### National Highway Traffic Safety Administration

#### New Car Assessment Program (NCAP)

**ACTION:** Final decision.

**SUMMARY:** This document announces the agency's decision to implement (with minor modifications) the planned update to the U.S. New Car Assessment Program (NCAP) that the agency announced in its June 26, 2013 request for comments (78 FR 38266). As we discussed in that request for comments, this update will enhance the program's ability to recommend to consumers vehicle models that have rearview video systems that the agency believes (based on currently available data) will decrease the risk of backover crashes. Further, the program will no longer list electronic stability control (ESC) as a Recommended Advanced Technology Feature because ESC is now required for all light vehicles. For many years, NCAP has provided comparative information on the safety of new vehicles to assist consumers with vehicle purchasing decisions. NCAP was most recently upgraded for model year 2011 to include recommended crash avoidance technologies. Those updates, along with today's updates to NCAP, allow

**Figure 1**

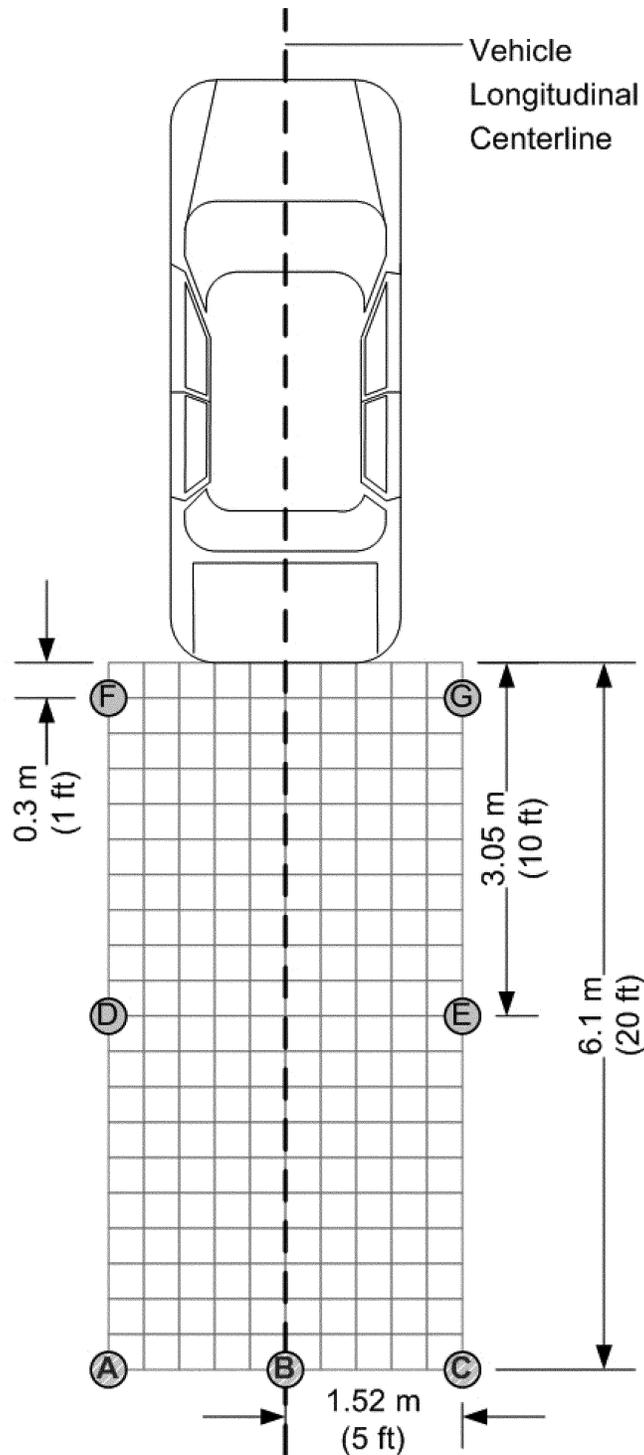
As proposed in the NPRM to amend FMVSS No. 111, the test procedure to evaluate the field of view (which covers 5 feet from either side of the vehicle center line to 20 feet longitudinally from the vehicle's rear bumper) would use seven test objects placed along the perimeter of the 10-foot by 20-foot zone behind the vehicle. See Figure 1, below. To meet the field of view criterion for the purposes of NCAP, a rearview video system would need to show the entirety of test objects A through E (the test objects greater than 10 feet behind the vehicle bumper) and show at minimum a width of 5.9 inches (150 mm) along any point of test objects F and G (the test objects only 1 foot behind the vehicle bumper). While manufacturers raised concerns with this criterion, we believe that it is appropriate to incorporate it (unaltered) into NCAP for the purposes of assessing rearview video systems in Phase 2.

Certain manufacturers expressed two concerns with this test procedure to evaluate the field of view criterion. First, both the Alliance and Global Automakers assert that test objects F and G should be placed in a location that is proportional to the vehicle width (as opposed to 5 feet to the left and right

of the vehicle centerline). They contend that vehicles using a 130 degree camera would not cover the required portions of test objects F and G (in their current locations). Second, the Alliance stated that certain vehicles with a low rear height (i.e., a vehicle that is not high off the ground) has less height flexibility for

mounting a camera. Thus, the Alliance suggests that vehicles with an upper protected surface of the rearmost body structure of 750 mm or less be required to show only a minimum height of 0.4 meters (half the height) of test objects A through E (objects greater than 10 feet from the vehicle bumper).

We disagree with the manufacturers that this procedure for evaluating the field of view criterion does not accommodate vehicles with rearview video systems using a 130 degree camera or vehicles with a low rear height. When we originally developed this test procedure for the NPRM to amend FMVSS No. 111, we specifically designed this test procedure to be able to accommodate these types of vehicle designs. In response to the manufacturers' first concern, it seems clear that if we take into account three-dimensional nature of a camera's field of view, a 130 degree camera will cover the specified areas of all the test objects even if the vehicle has a low rear height. In tests conducted by the agency, the vast majority of vehicles equipped with rearview video systems were capable of meeting the field of view requirements as proposed in the NPRM.<sup>13</sup> Thus, we are unaware of any camera that has a vertical angle limitation which would prevent it from easily being mounted at a pitch which covers the full height of test objects A through E.

In response to the manufacturers' second concern, we note that the portions of the F and G test objects that must be shown are measured by width only in order to accommodate vehicles of varying height and width. Thus, we disagree with the manufacturers that a 130-degree camera is unable to cover the width parameters for test objects F and G. We believe that the diagrams presented by the commenters regarding the inability of the 130-degree camera to cover test objects F and G fail to consider the three-dimensional properties of a camera's viewing angles. As Magna, a rearview video system manufacturer, stated in their comments to the NPRM to amend FMVSS No. 111, a 130-degree camera can readily cover the 5.9-inch (150-mm) width parameters of test objects F and G when mounting height and camera pitch is considered.<sup>14</sup>

Since the available information indicates that existing systems either already conform to (or can be easily adjusted to conform to) the field of view criterion from the June 26, 2013 request for comments, we believe there is no reason to adjust this criterion to reduce the field of view below the 10-foot by 20-foot zone where there is the highest risk of a backover crash.
